Detailed Site Plan Alternative Compliance Breighton Hills Condominiums

DSP-94052-03
AC-95023-01

SUBJECT: Detailed Site Plan DSP-94052-03
 Alternative Compliance AC-95023-01
 Brighton Hills Condominiums

Figure 2: South Elevation

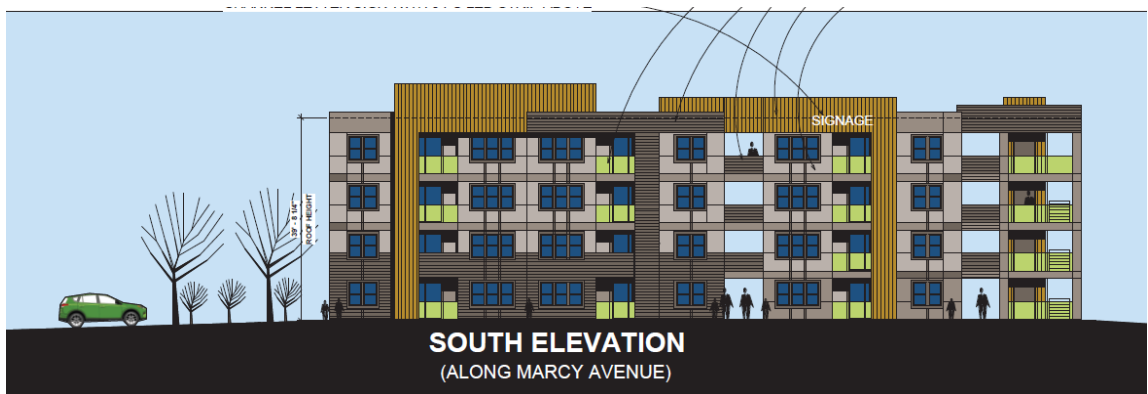
One building-mounted sign is proposed. The aluminum channel letter sign is illuminated and is approximately 8 inches high by 6 feet long. The submitted elevations show the sign on the southern building elevation, but details to fully evaluate the sign have not been provided. A condition has been included herein, requiring the applicant to provide scaled details of the signs and elevation drawings showing its design.

- j. Provide details of the trash enclosure and the building mounted sign, in accordance with prior Section 27-618 of the prior Prince George's County Zoning Ordinance.
